**Urban Design Review**

# **Barton Street Monterey**

The accompanying document is a review of the Development Application for Summitcare Monterey, Submitted by Boffa Robertson, and as amended to 8<sup>th</sup> November 2021.

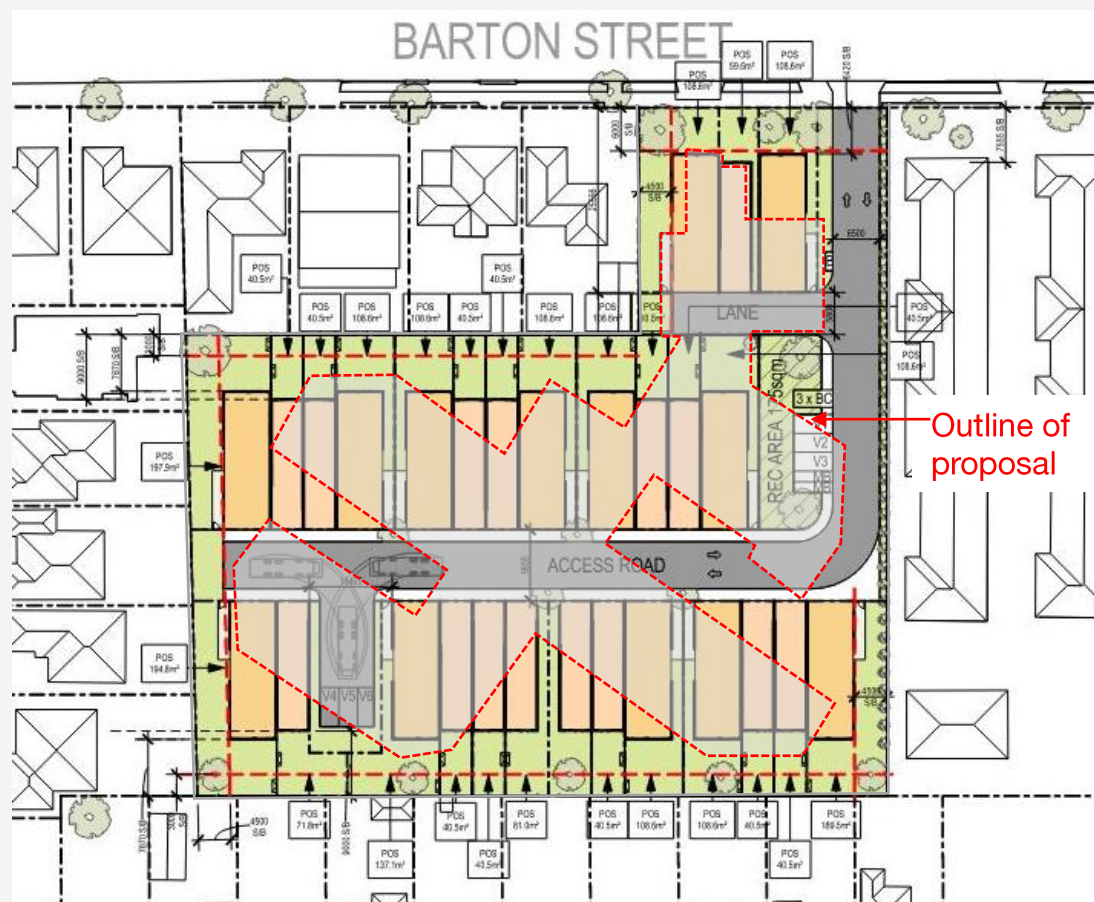
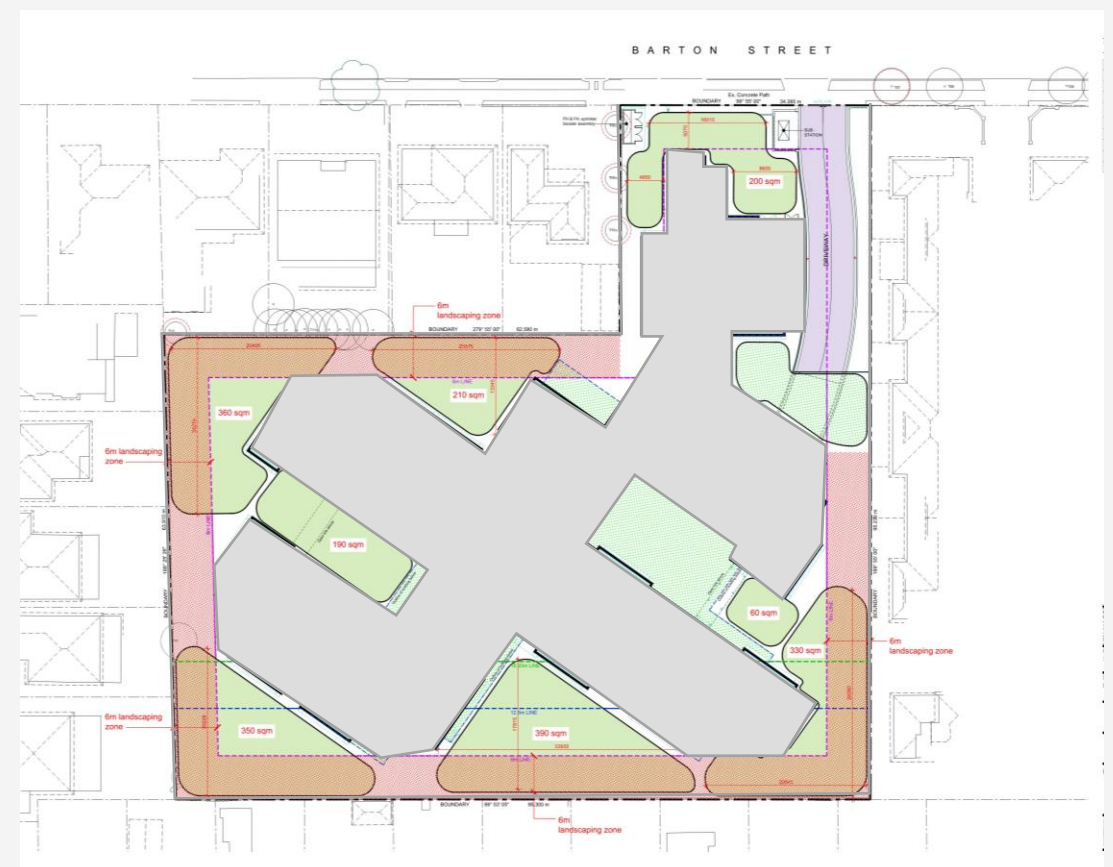
The key observed difference between the Reference masterplan and the DA submission is the building footprint.

The building proposal submitted breaks the form into 4 distinct wings, rotated on the site.

The rear building forms differ from the endorsed masterplan through the creation of 3 rotated and interconnecting wing forms.

These wings maintain similar, or in some cases great setbacks and separation to

the neighbours, but present the ends of wings to neighbours, rather than a long continuous form. This means that the vast majority of the neighbours instead face a landscaped open space with deep soil planting.

Whilst the building footprint as a result is large, the stepping and orientation means that it presents as a much smaller building than would be the case if it was parallel to the sites boundaries.

As a result, this is a solution that mitigates the bulk and scale of the development to the surrounding context, with predominantly 1 or 2-storey forms presenting to neighbours, and 3-storey elements consolidated in the centre of the site.

Extract from Boffa Robertson DA Submission drawings

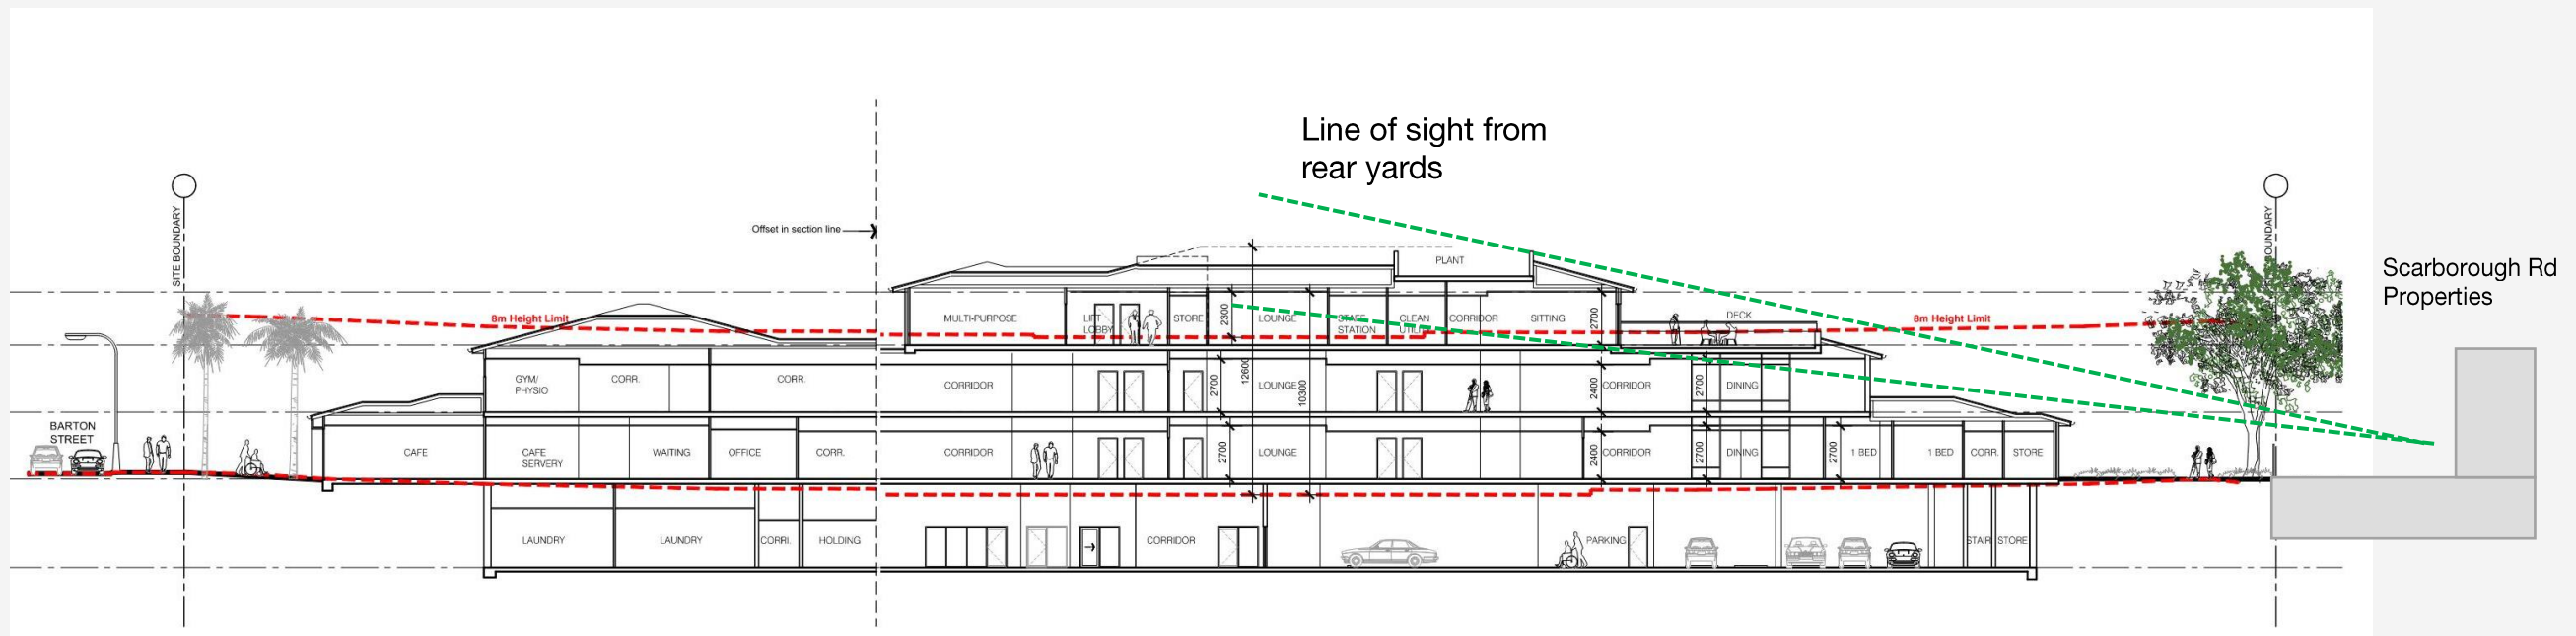
The most significant deviation from the endorsed masterplan is the inclusion of a third level within the proposal.

This third level is located within the centre of the subject site and has been reviewed against its impact on adjacent properties, and amenity for those surrounding dwellings.

The third level has been predominantly recessed within the roof form of the scheme which assists to reduce its visual bulk and appearance from the neighbouring sites. The supplied cross section with comments below shows the extent of the third level that will be apparent to development from the south of the subject site. This is shown as very limited given is setback to neighbours, with only small portions of the third level roof visible.

Key items to consider as part of the design is views and privacy from the roof top terraces to primary private open spaces of adjacent neighbours. Privacy screens and orientation of the terraces needs to be considered in order to provide a more balanced sharing of amenity between sites.

The rotation of the building on the subject site creates an orientation of these roof terraces away from the neighbours. This should allow for appropriate positioning, and selection of heights for privacy screens. These screens would then remove any remaining privacy and overlooking concerns and assist in creating an appropriate transition to adjacent neighbours.

Extract from Boffa Robertson DA Submission drawings

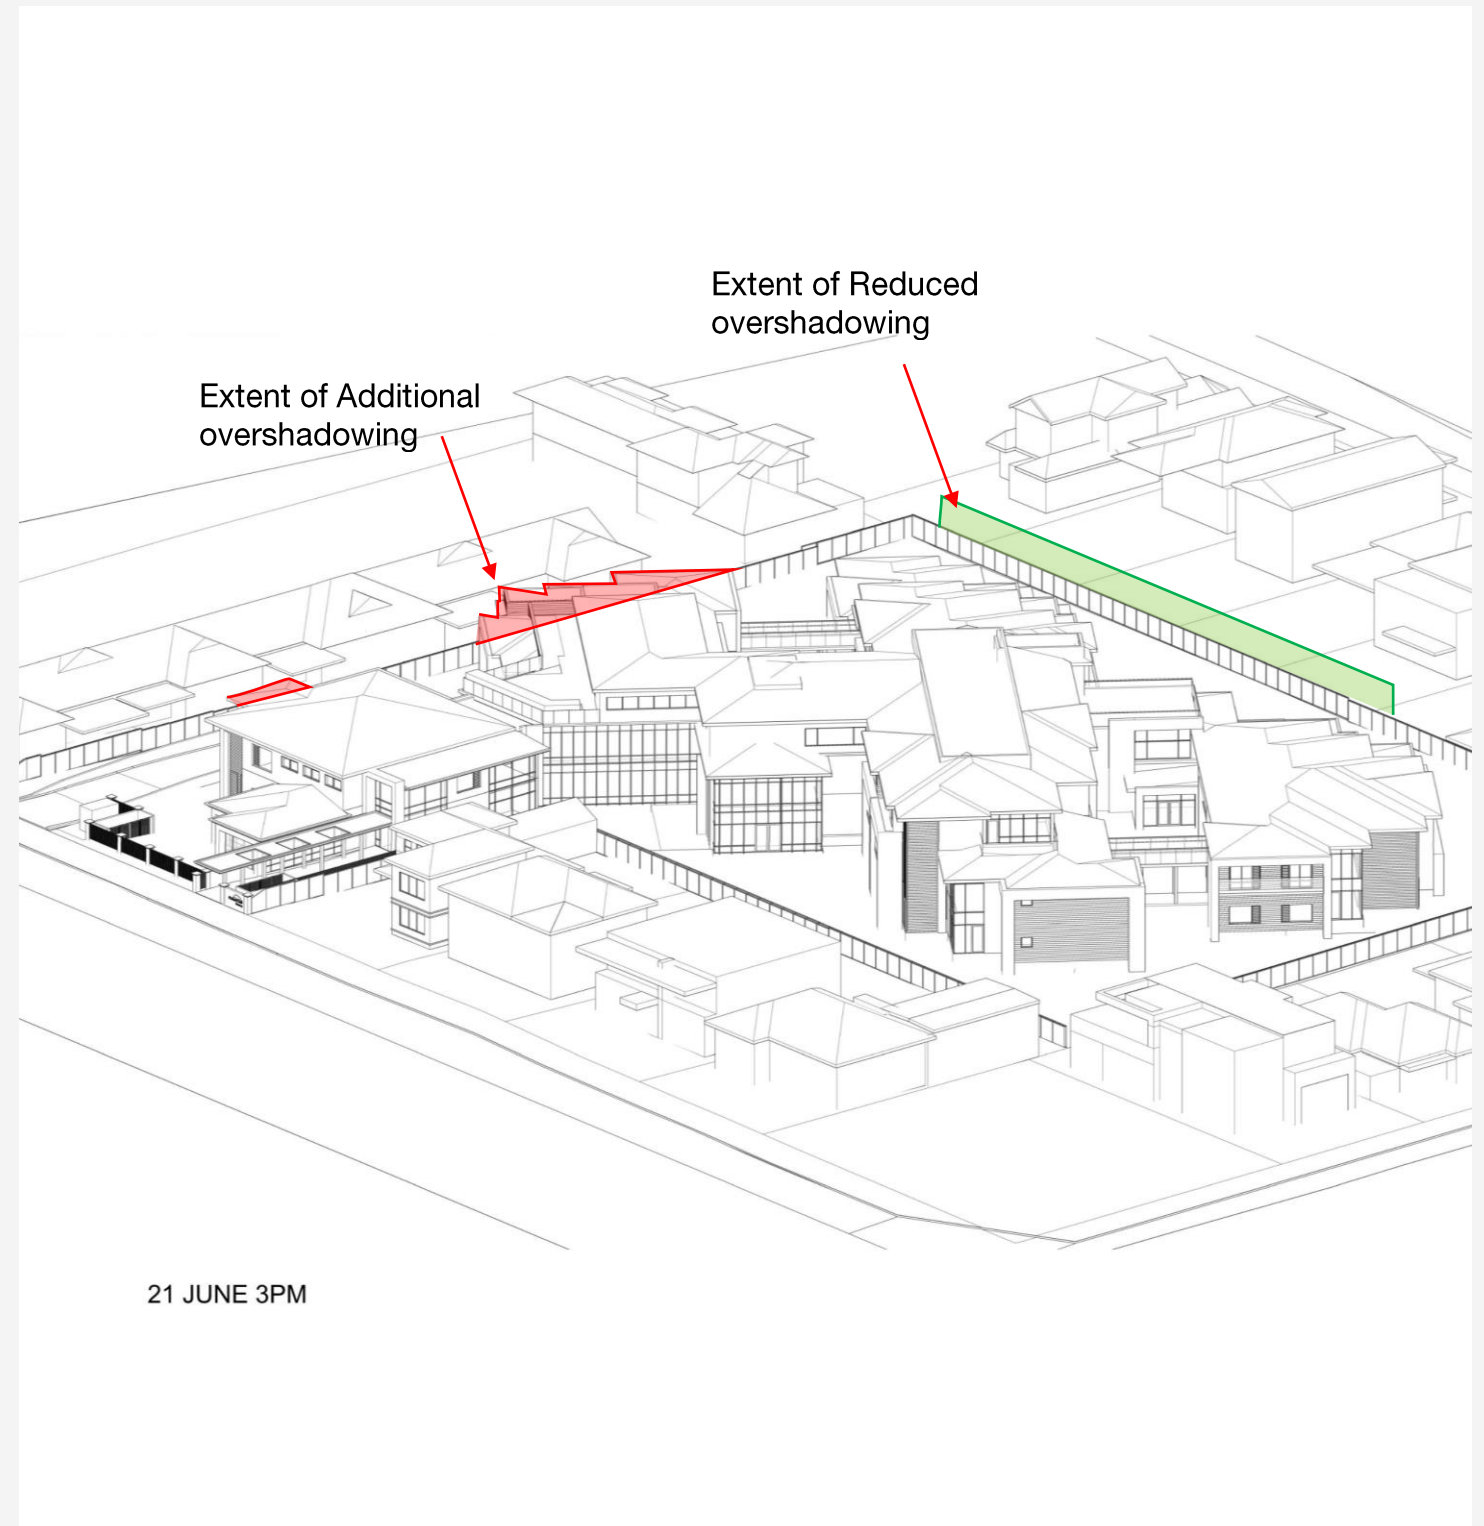
Reviewing the design proposal against the overshadowing analysis submitted with the Planning proposal identifies on minor additional overshadowing to neighbouring properties.

This overshadowing occurs only at 3pm on the Winter Solstice, with a portion of the building overshadowing part of the property at 121 Barton Street.

The dwellings at 121 Barton street are not overshadowed by the subject proposal at other times on the 21st June and could be demonstrated through more detail solar analysis to receive the required amount of solar access.

The Design proposal has a more significant increase in setback to the southern boundary shared with 9 separate properties, and as such leads to an increase in solar access for those dwellings, than was anticipated in the reference masterplan.
